Seagate Technology

RE: Login Query move

The following proposal is intended to move the function of the Login Query ORB to CSR space.

Figure 1 - Login ORB format

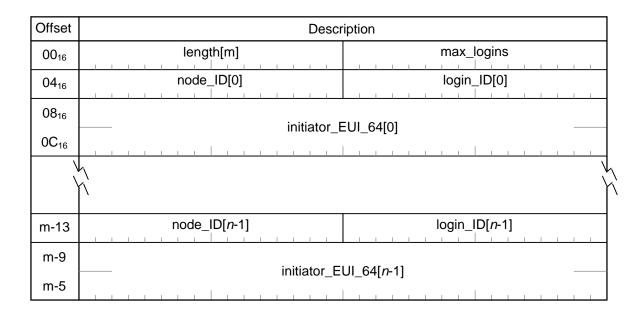
Since the Login Query management function is the only function that forces a device to respond to an initiator that is not logged in, this proposal requests that the information contained in the response to a Login Query function be moved to CSR space. This change moves all unprotected data to either CSR space or Configuration ROM. It also simplifies target functionality since no special case exists for the handling of any ORB function.

The format of the Login Query CSRs is shown below:
